#### PLANNING COMMISSION MEETING AGENDA CITY OF WHITE BEAR LAKE, MINNESOTA

SUBJECT:	Walser Polar Chevrolet, 1801 County Road F - Case No. 19-1-CUP & 19-1-V
DATE:	February 21, 2019 for the February 25, 2019 Planning Commission Meeting
FROM:	Samantha Crosby, Planning & Zoning Coordinator
ТО:	The Planning Commission

TO:	Samantha Crosby, Associate Planner
FROM:	Connie Taillon, P.E., Environmental Specialist Dan Holzemer, Senior Engineering Technician
DATE:	February 6, 2019
SUBJECT:	Walser Polar Chevrolet Engineering Review Comments

C-4.0

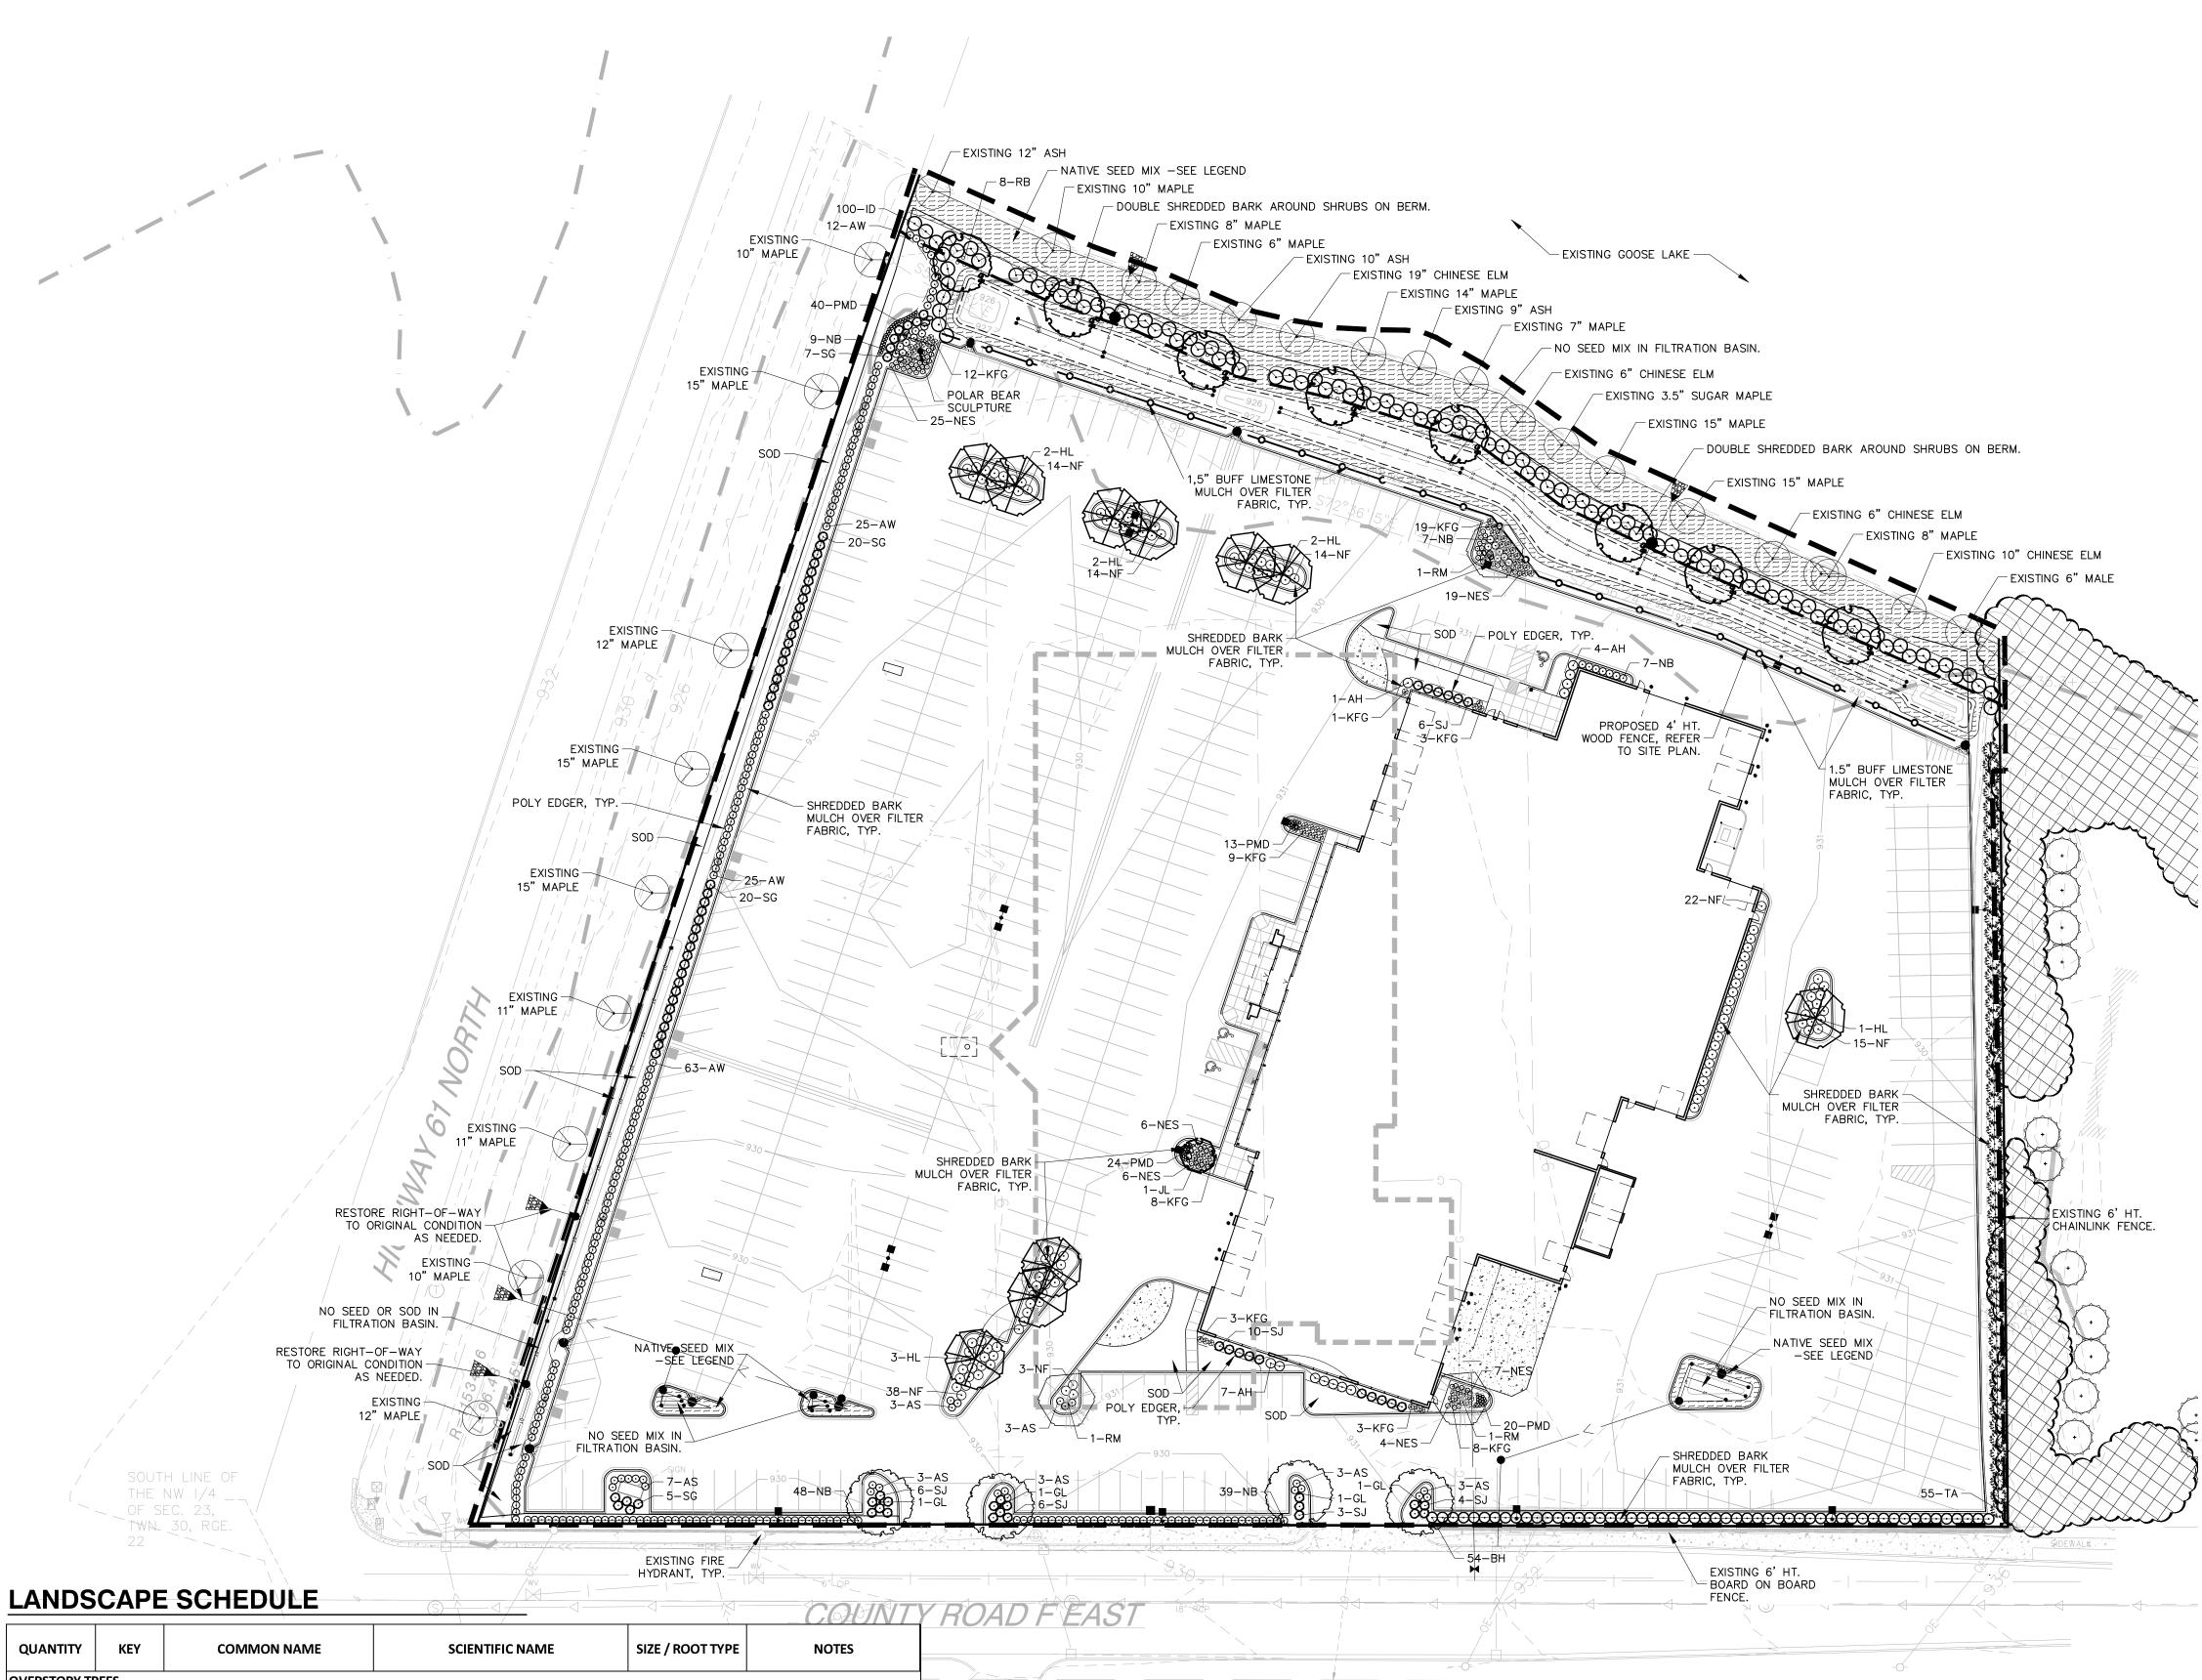
- 16) Add the 927.8 BFE (NGVD29) to the plan.
- 17) Include MnDOT ROW permit language in Note 14.
- 18) Add a rain guardian at the end of the valley gutter that flows to basin 2 on the west side of the site. Move the proposed light pole out of the flow path of the valley gutter.
- 19) Match crowns of the inlet and outlet storm sewer pipes if possible.
- 20) Revise the 8" storm sewer pipe diameter in the CB1 and CB8 callouts to match the 12" pipe callouts.
- 21) Structure CB1 and CB8 are only 1.8 feet deep, are these structures buildable? Check the depths of all manholes to determine if they are buildable.
- 22) Move the valve box for the new 6" service to the sidewalk
- 23) Show abandonment plan for existing services

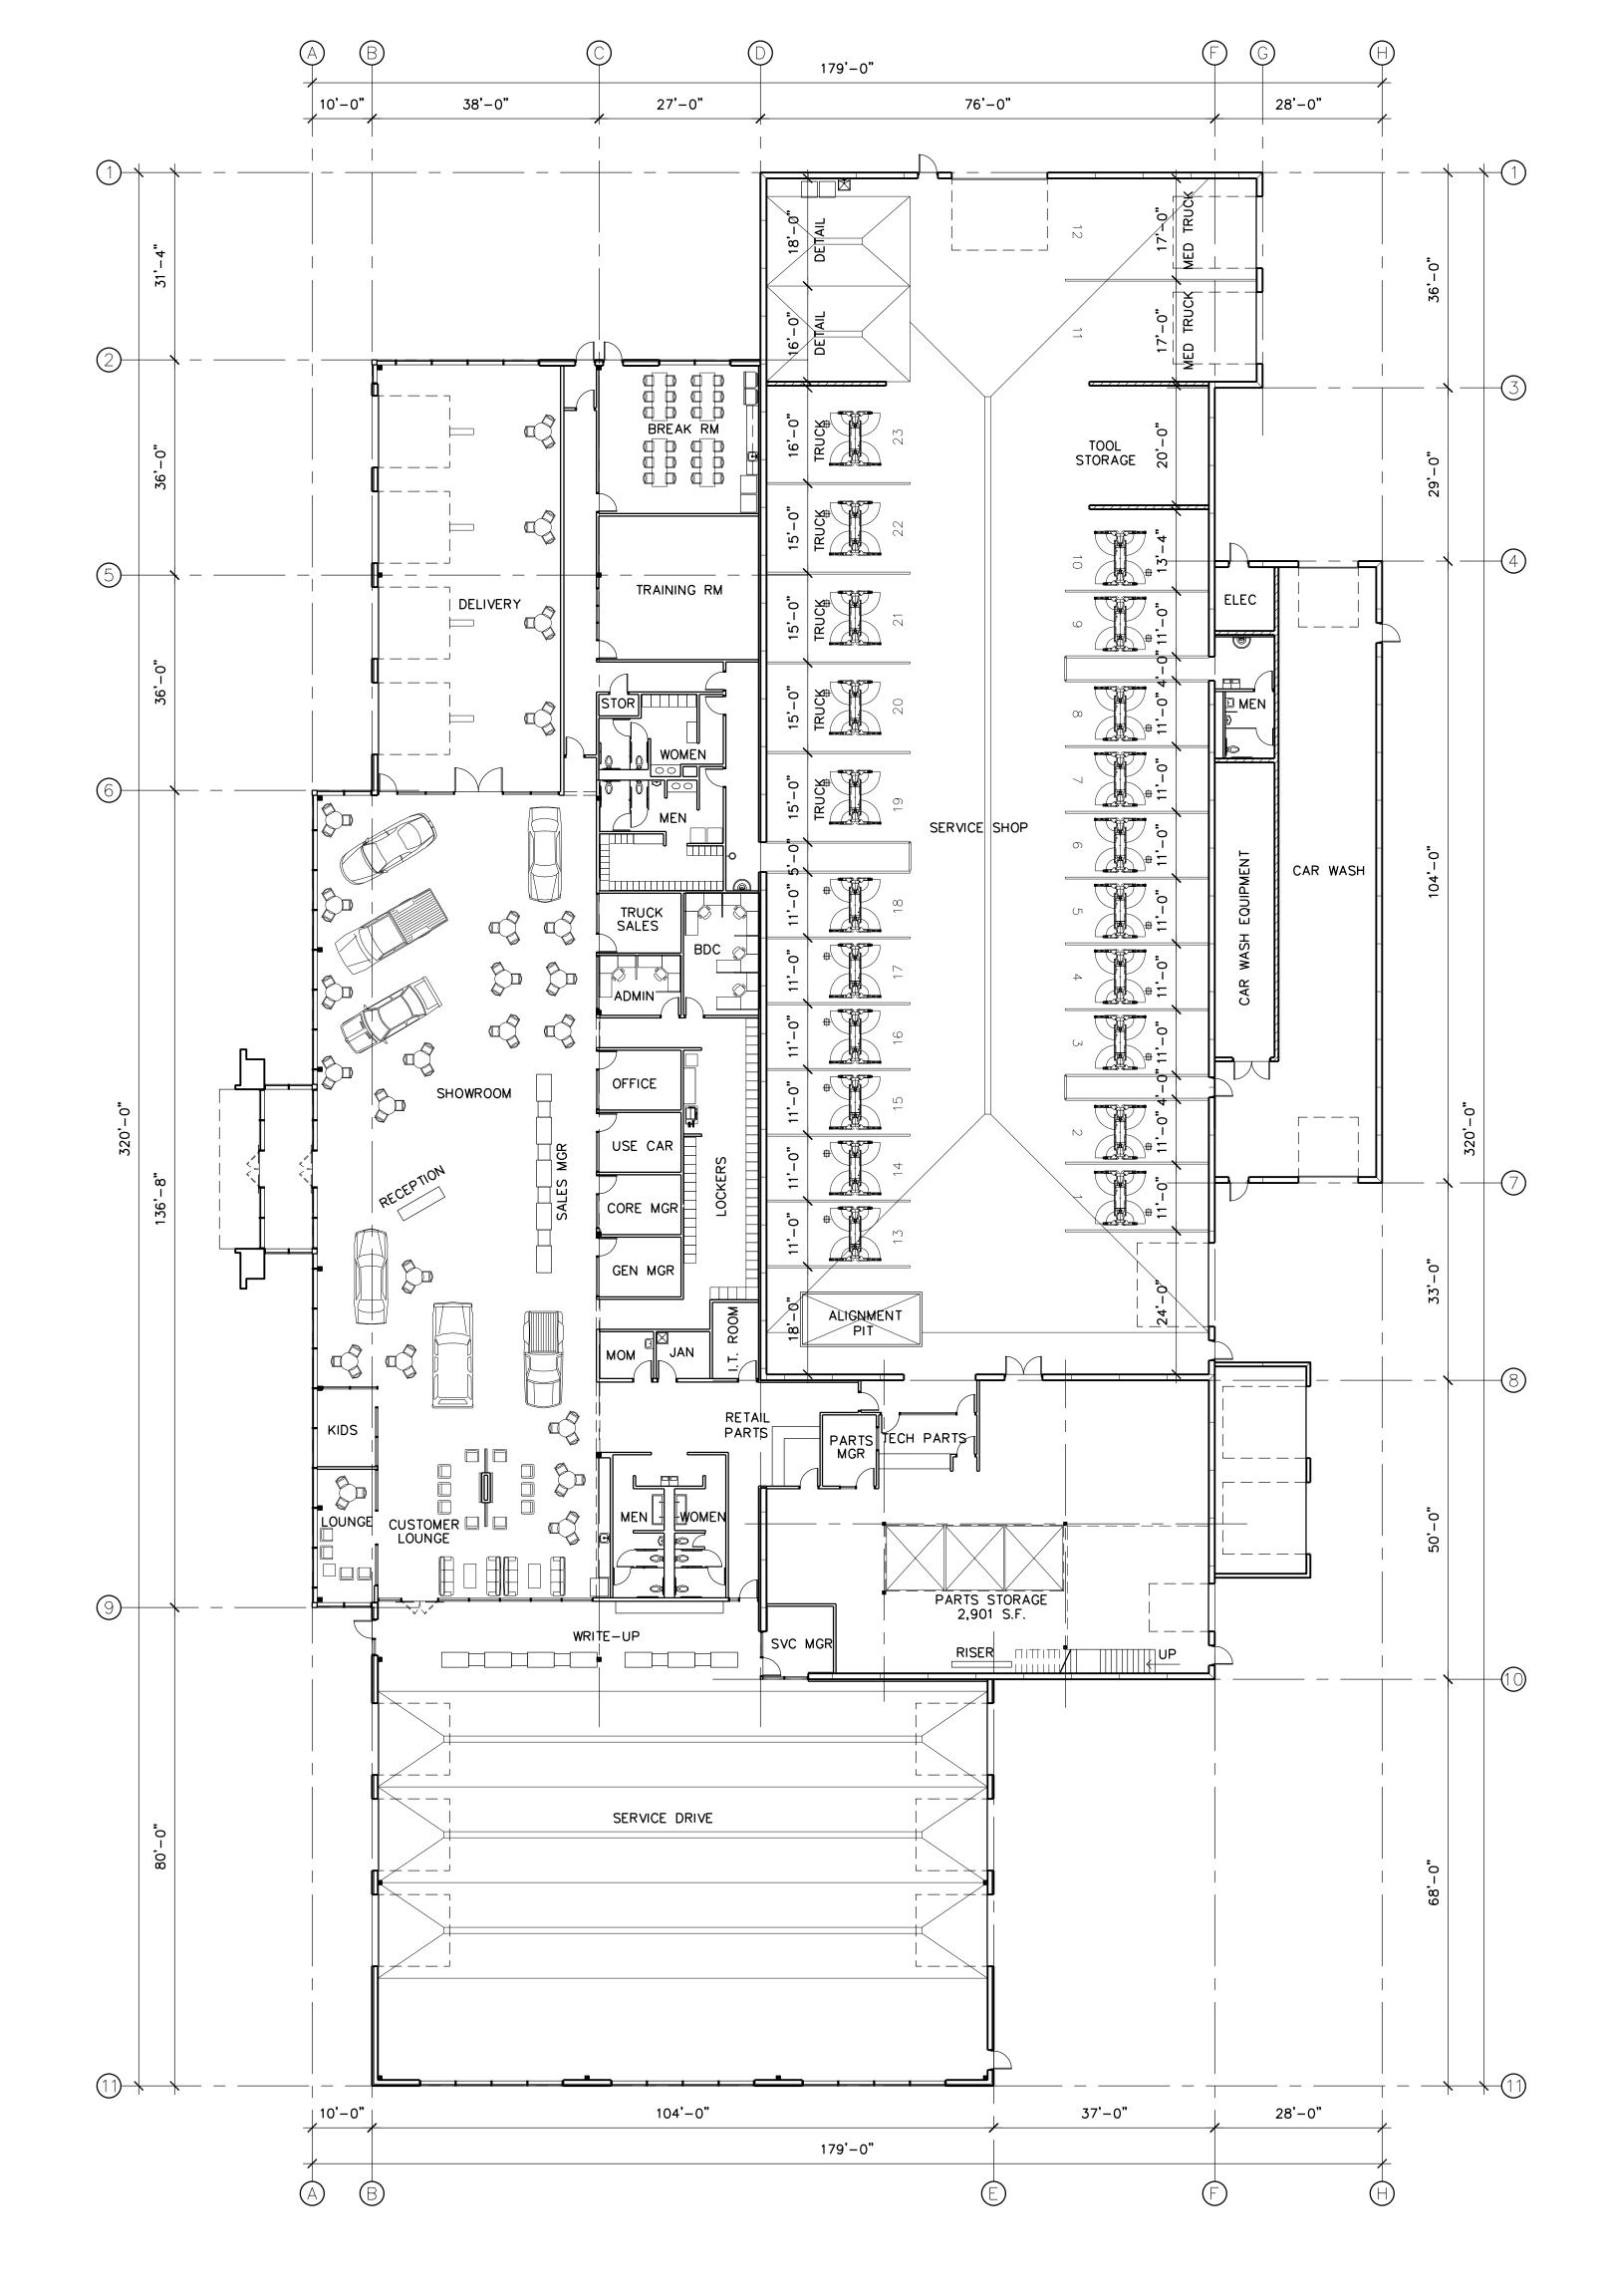
- 29) Sod and topsoil are not allowed in the filtration basin. Please add the words 'sod' and 'topsoil' to the all of the filtration notes that state 'No seed mix in the filtration basin'
- 30) All vegetated areas to the north of the fence in the 25-foot lake buffer and surrounding the filtration basin shall be planted with native plant species. Consult the shoreline restoration contractor for the appropriate species to plant in this area (and around the other four filtration basins) and either revise this plan sheet accordingly or submit a separate landscape plan from the shoreline contractor. Trees are not recommended on top of the berm in order to keep leaves and other debris from clogging the surface of the iron enhanced sand filter.
